**CERTIFICATE OF APPROPRIATENESS**

**Property:** 812 W Fugate, lot 7, block 205, East Norhill Subdivision. The property includes a historic 1,202 square foot, one-story wood frame single-family residence and a detached garage situated on a 5,512 square foot (53' x 104') interior lot.

**Proposal:** Alteration – Revision to a previously approved approximately 500 square foot addition to the rear of the 1,202 square foot residence. The applicant received approval in October 2014 for a rear addition that connected to the existing garage. In November of 2014, the roof was removed without approval or permits. The applicant is now seeking approval to:

**Basis for Issuance:** HAHC Approval  
**Effective:** December 17, 2014

**NORTH ELEVATION – FRONT FACING W FUGATE**  
**ORIGINAL**

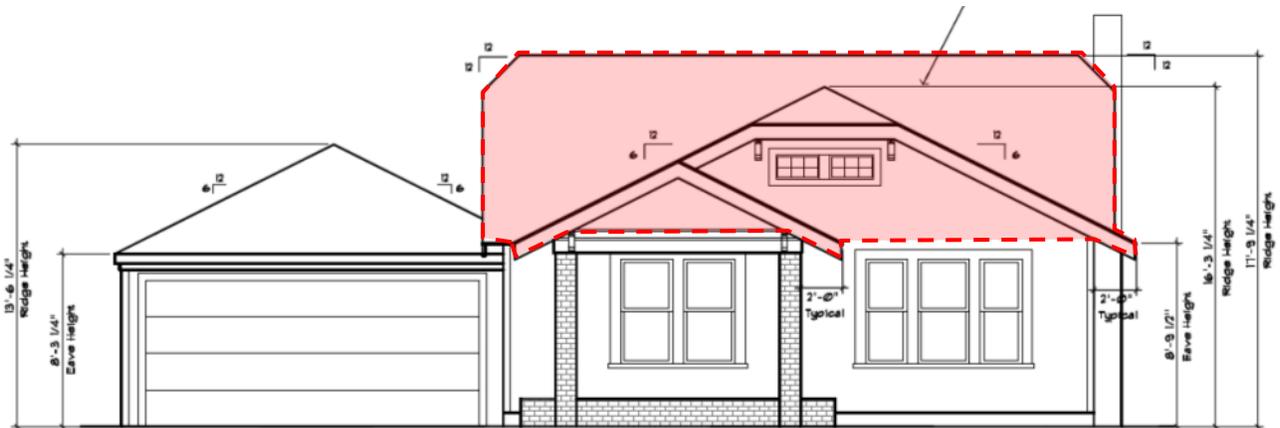
REBUILD ROOF TO ORIGINAL CONDITION

**EAST SIDE ELEVATION**

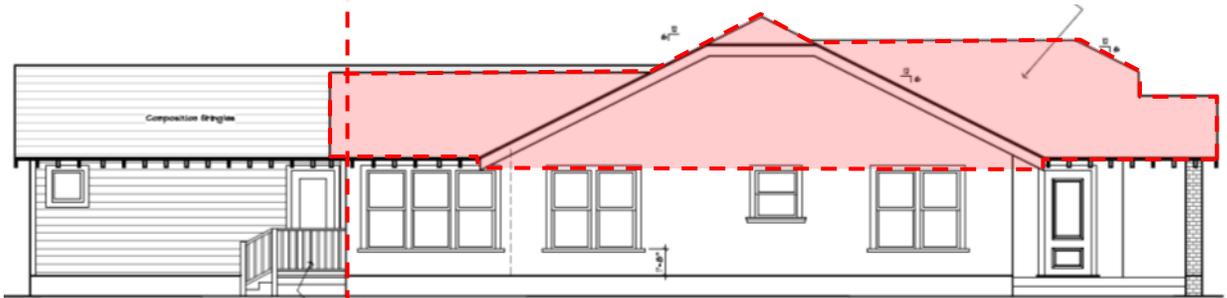
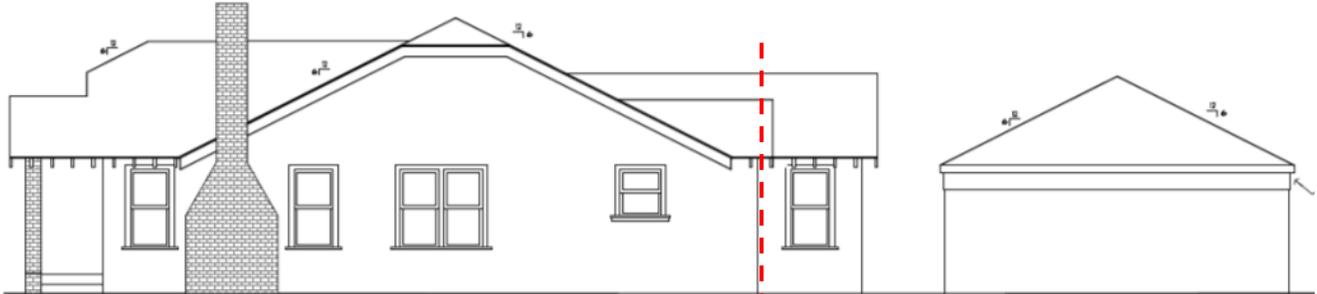
*REBUILD ROOF TO ORIGINAL CONDITION*

**WEST SIDE ELEVATION**  
**ORIGINAL**

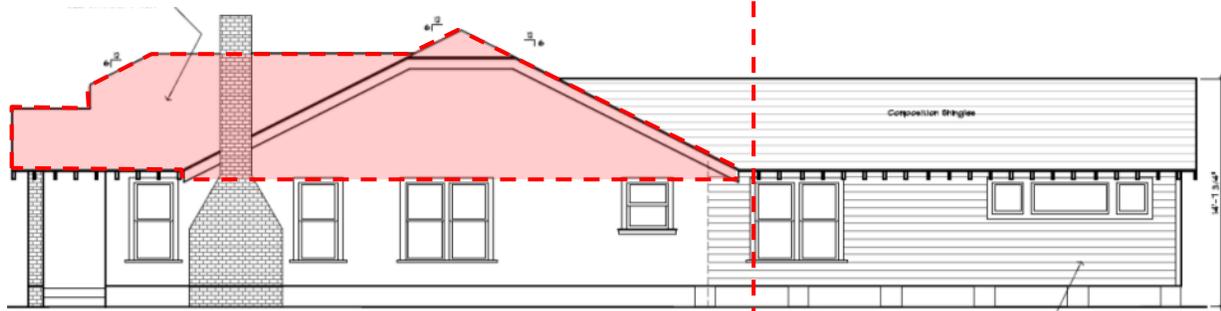
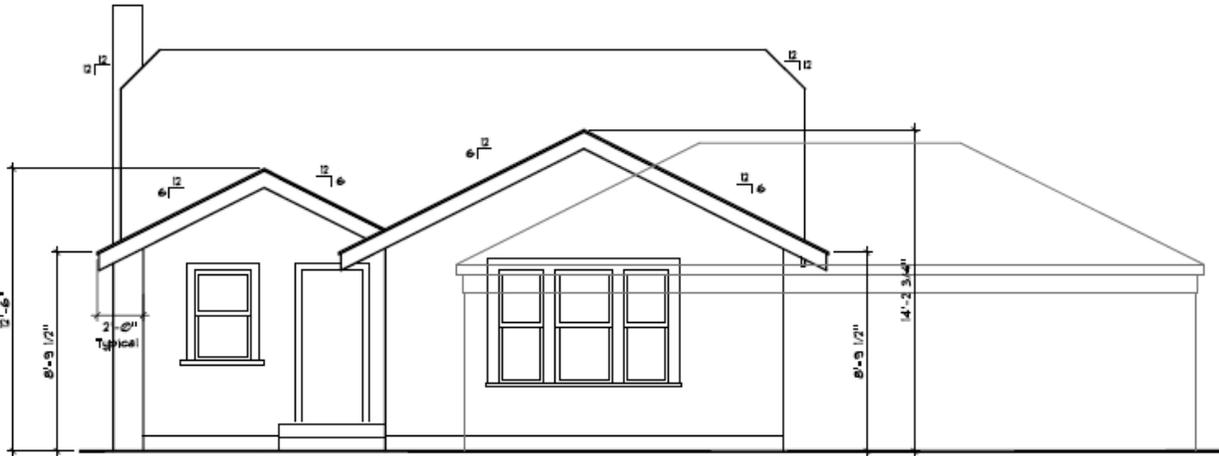
*INSERT TWO WINDOWS*

*REBUILD ROOF TO ORIGINAL CONDITION*
